23rd October 2015

Response to Agency Comments on Civil Drawings and Report – The Next Generation, Energy from Waste Plant, Eastern Creek

SSD 6236 – Energy from Waste Facility Memo from Blacktown City Council

Title
PROPOSED FUTURE CONTOURS

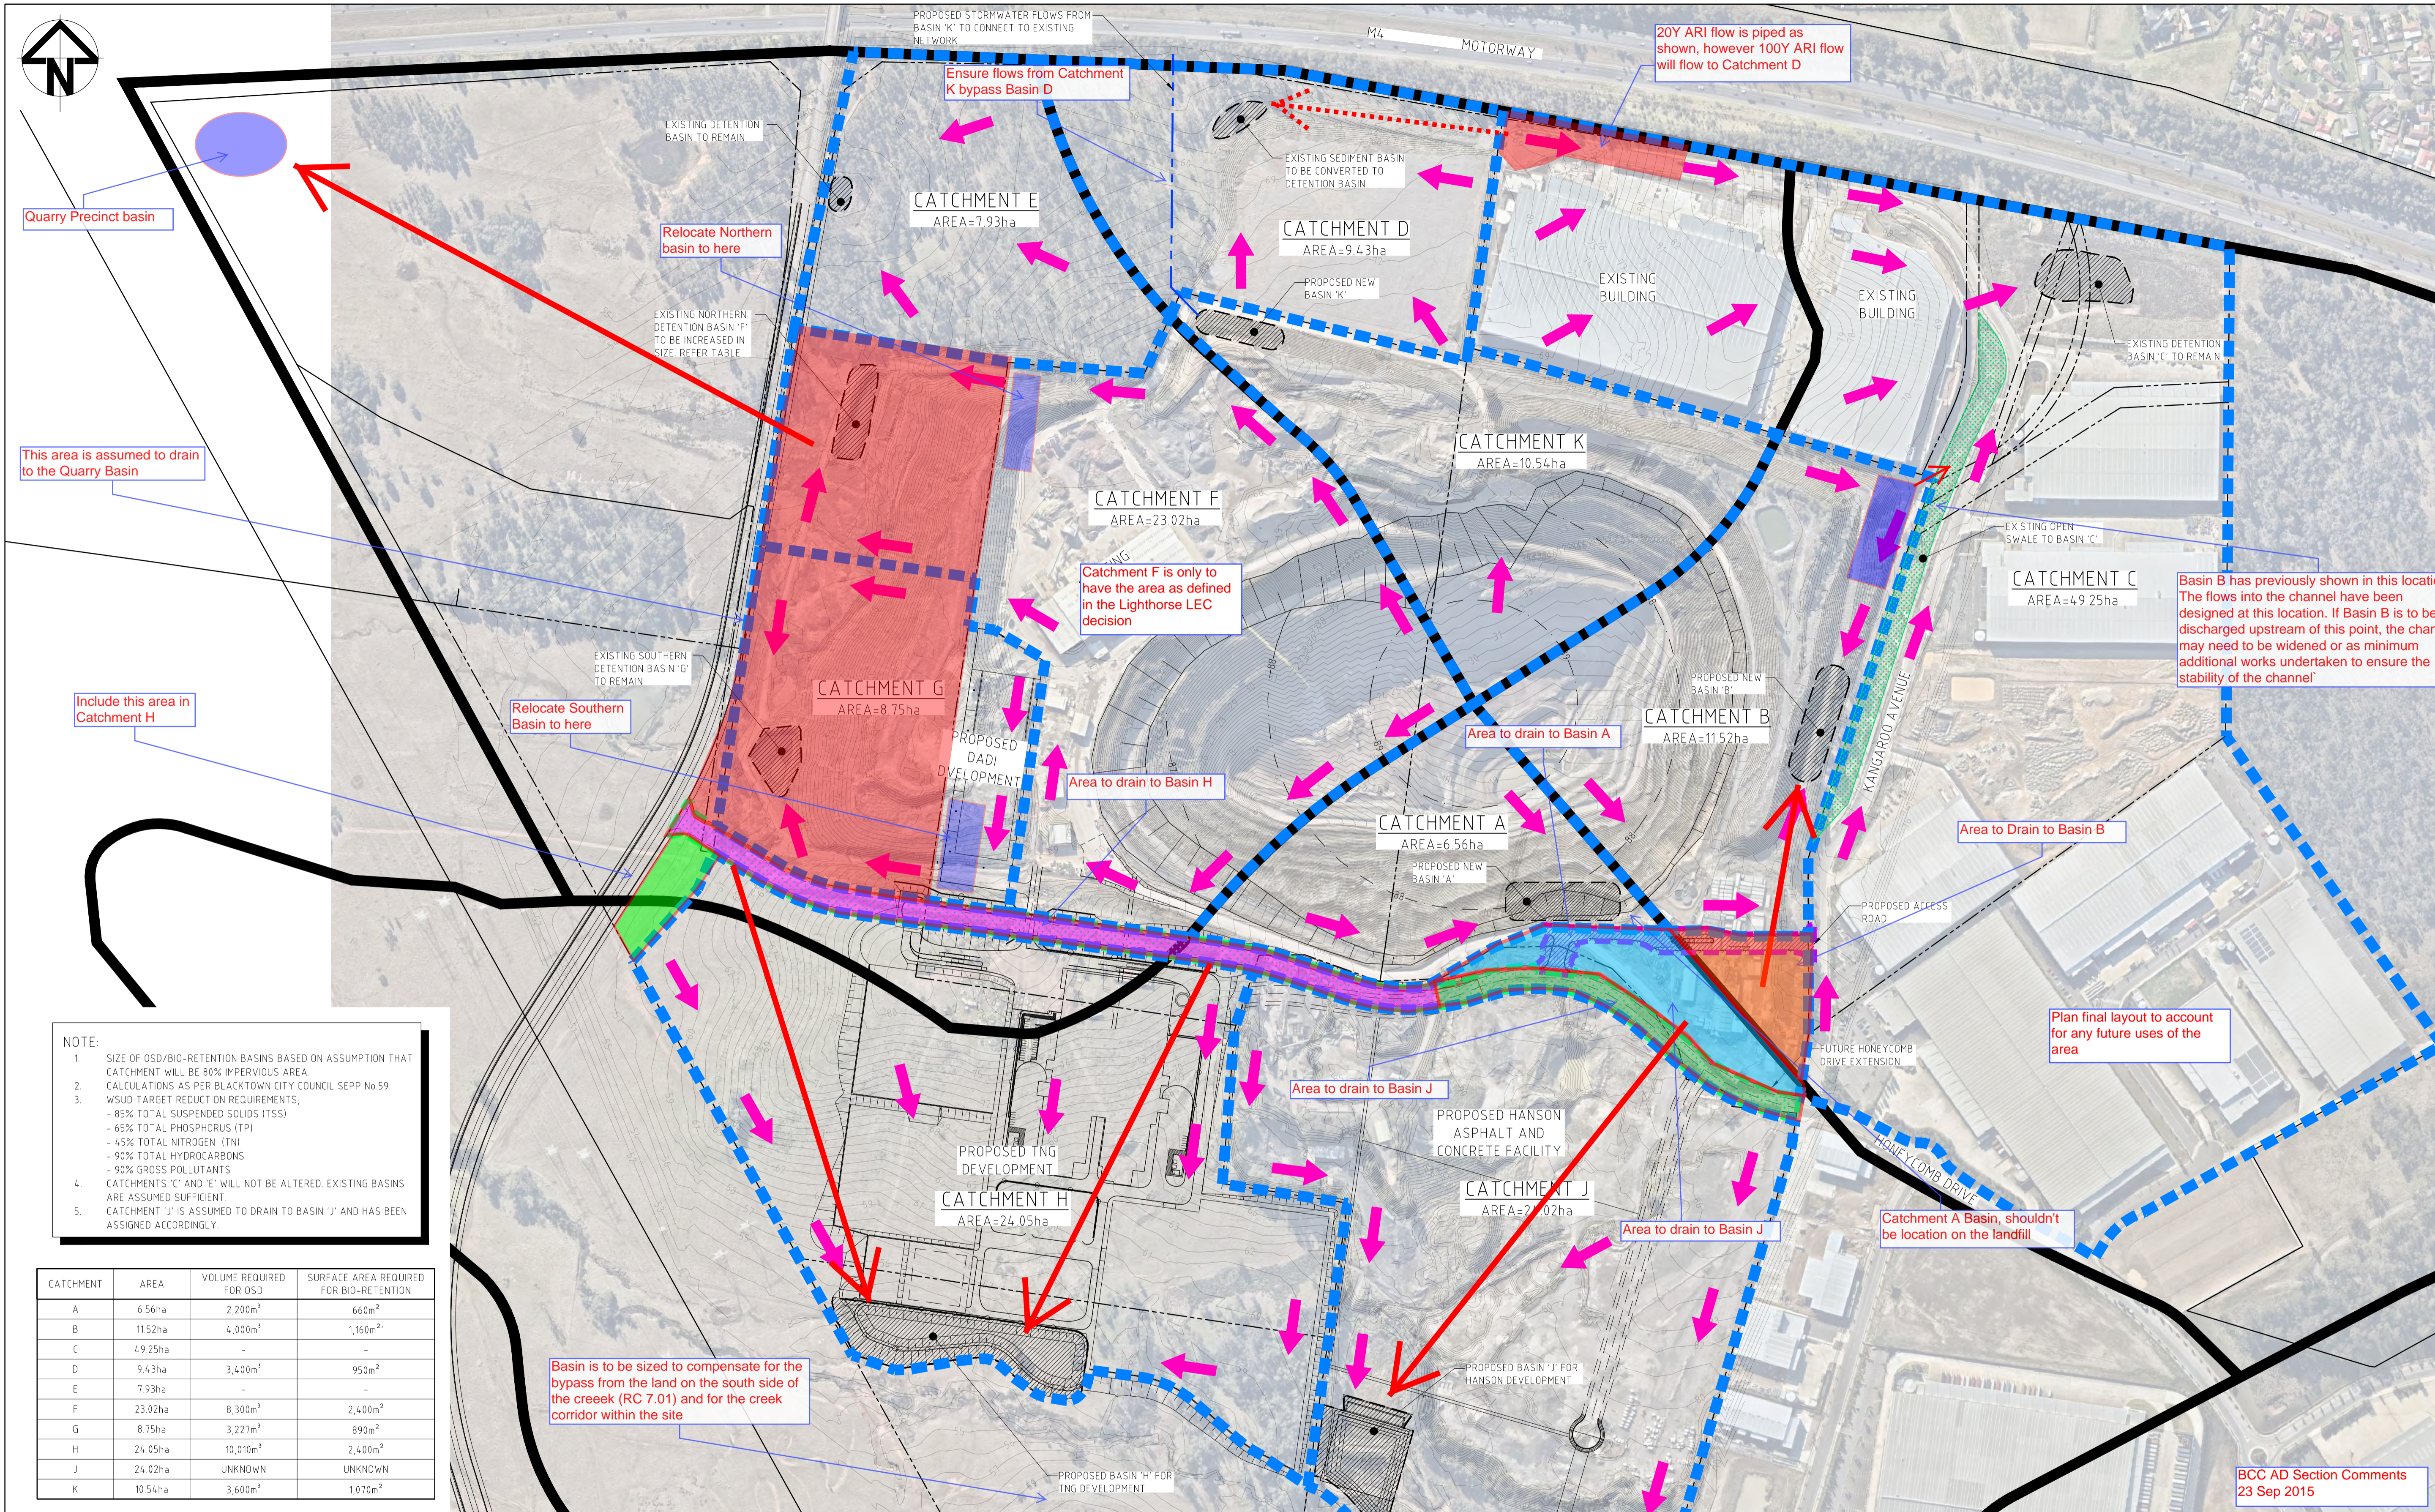
The proponent's engineer has prepared a catchment plan for the future stormwater management of the DADI site, as required by a LEC decision. Generally, this is in accordance with Council's catchment plan, referred to above. A marked up copy of this plan is attached and summarized below:

- Basin H provides detention not just for the site, but under the Precinct Plan also provides compensatory detention for the land on the southern side of the creek (catchment rc 7.01 in Council's catchment plan).
- Part of Catchment G is to be managed in the Quarry Catchment Basin. The existing basins need to be relocated to within the approved Lighthorse area.
- The overall stormwater management strategy should facilitate future development of the site
- There are areas in Catchments A and B that need to be managed prior to discharge.
- Basin B is to be located in the north east corner of the catchment. If it is located further up the channel, the channel may need to be widened to convey the additional flow or as a minimum additional works to ensure stability of the channel.

- Drawing SKC007 24.05 ha
- Drawing SKC35 22.3 ha
- DRAINS model 22.277 ha
- MUSIC model 23.198 ha

These areas are to be corrected so that they are consistent.

SITE CATCHMENT PLAN

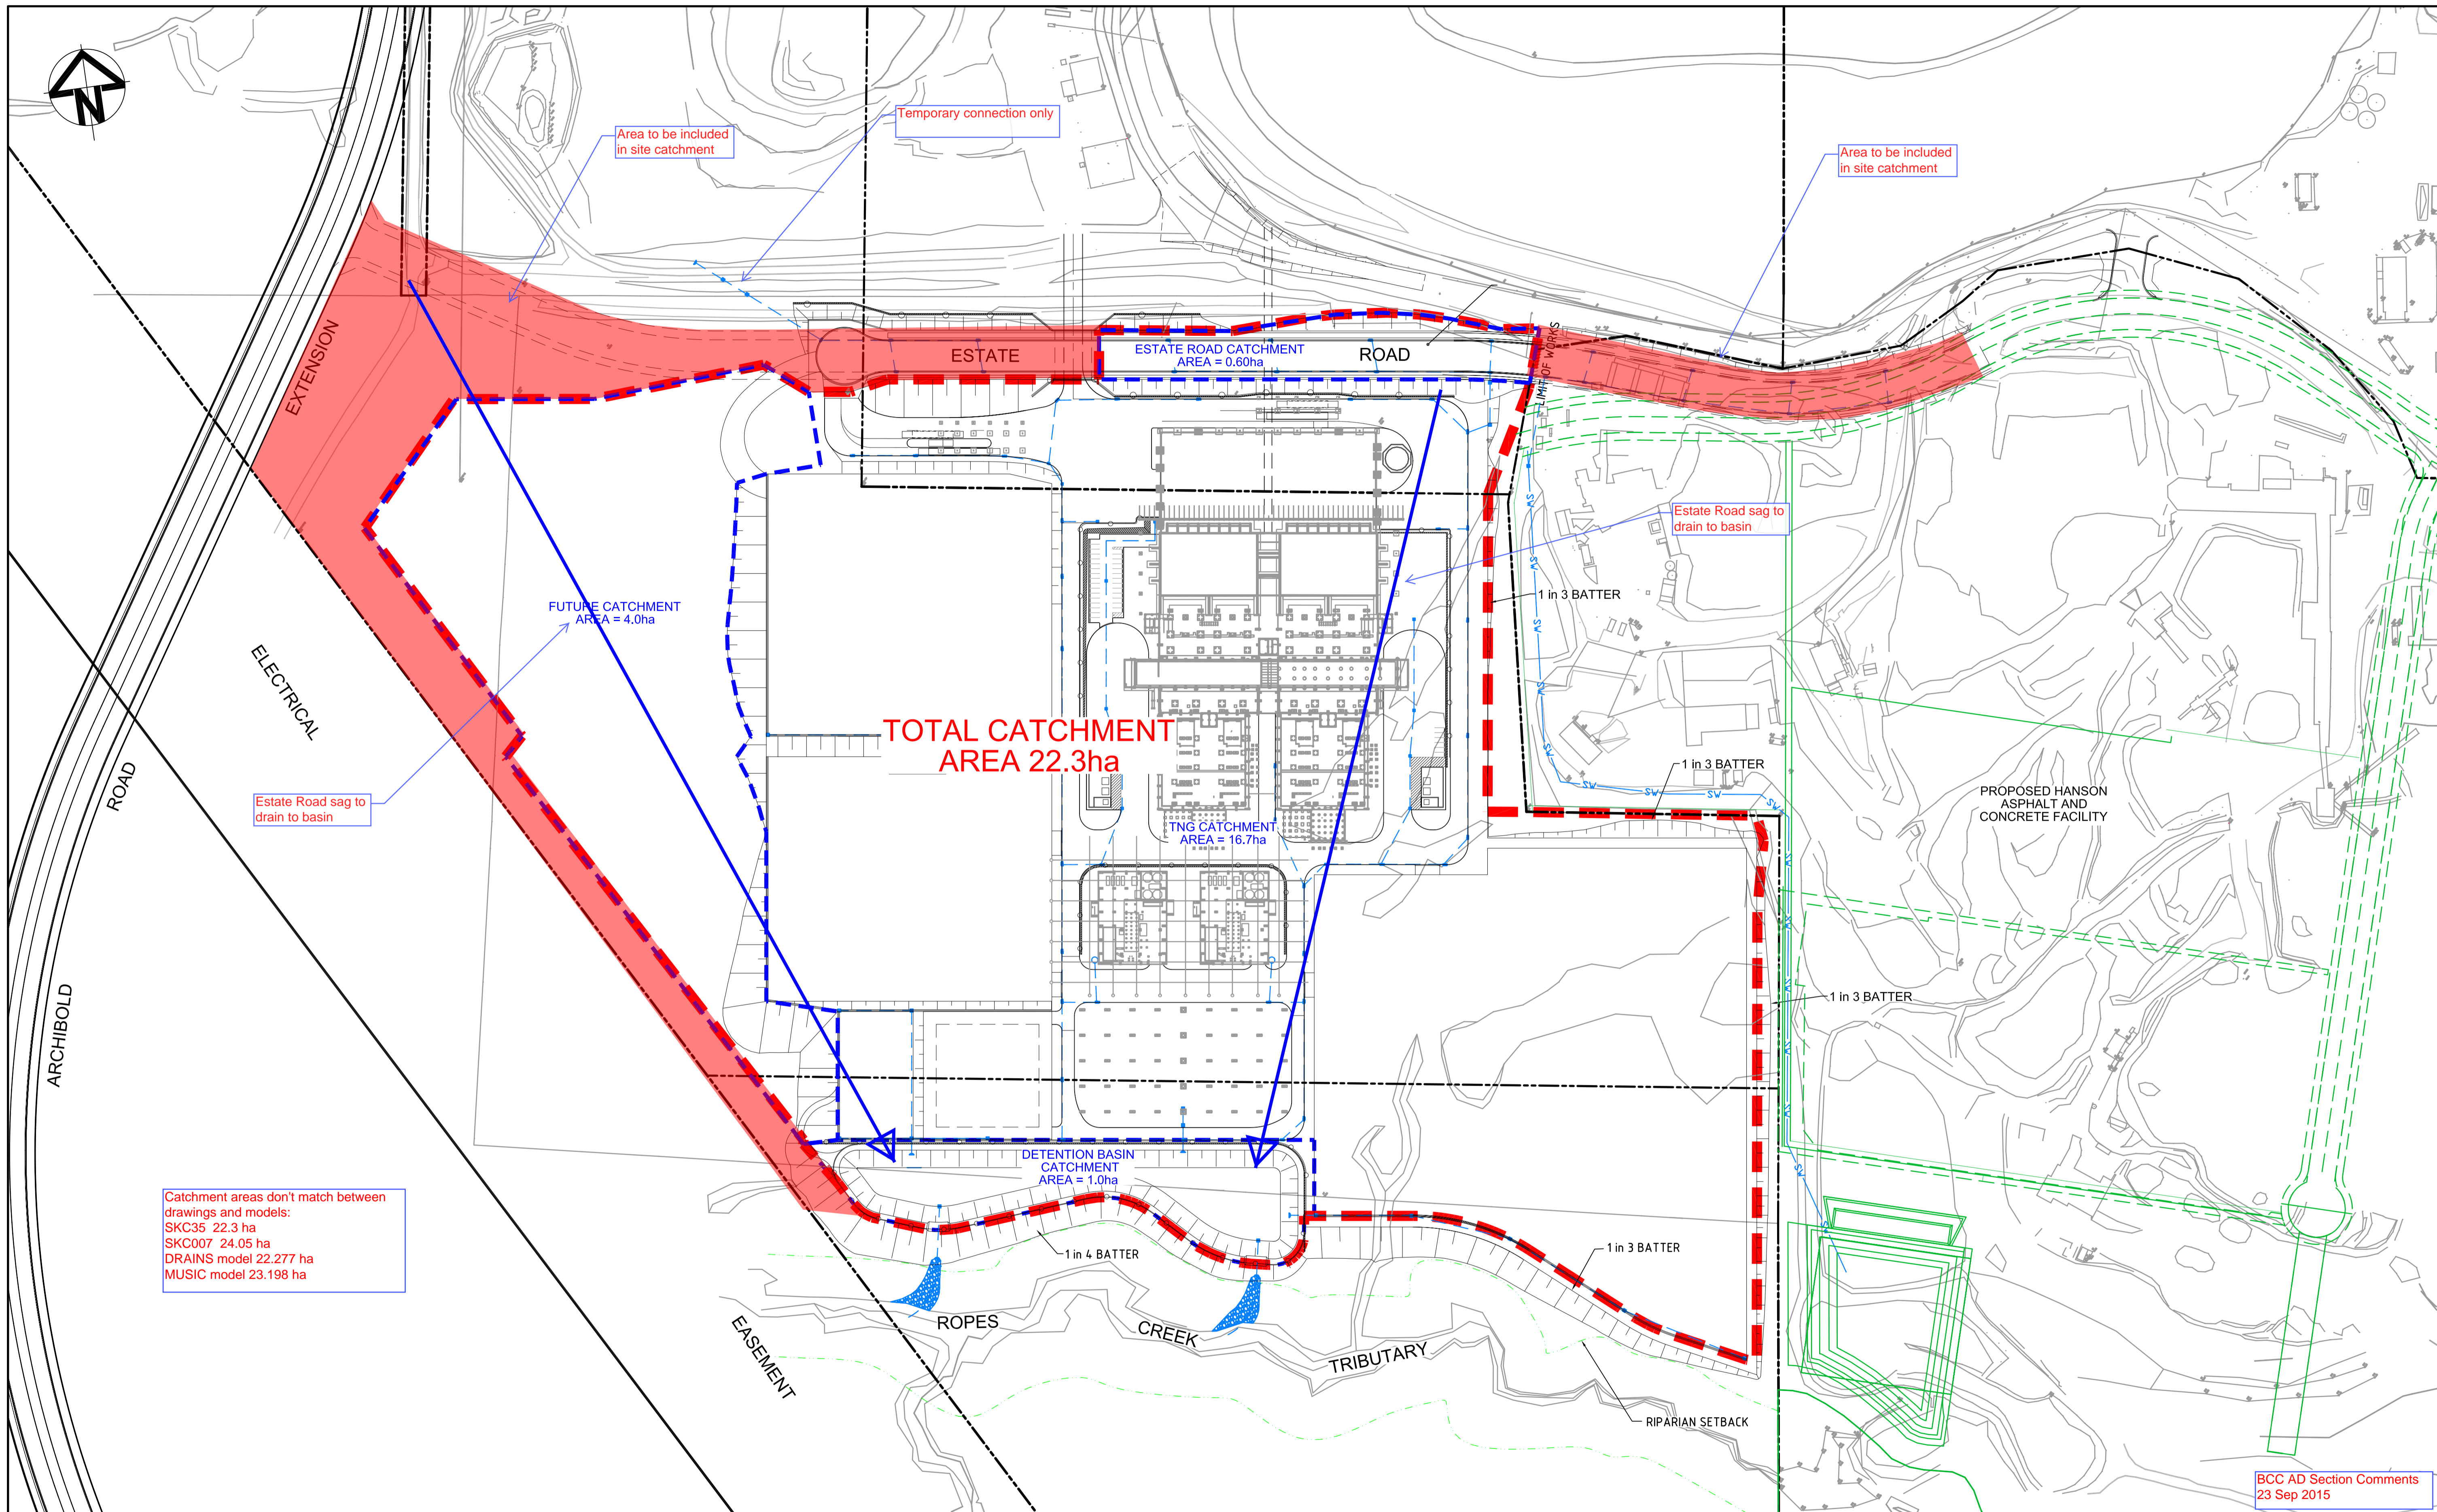
Catchment areas don't match between drawings and models:
 SKC35 22.3 ha
 SKC007 24.05 ha
 DRAINS model 22.277 ha
 MUSIC model 23.198 ha

AT&L Response: All stormwater runoff is proposed to be treated in the precinct bio-retention basin. This includes the entire catchment area as indicated in our Site Catchment plan SKC35 plan issued to BCC on 04/09/2015. As it has been confirmed the basin will be dedicated to BCC and act as a Precinct Basin the flows can be mixed.
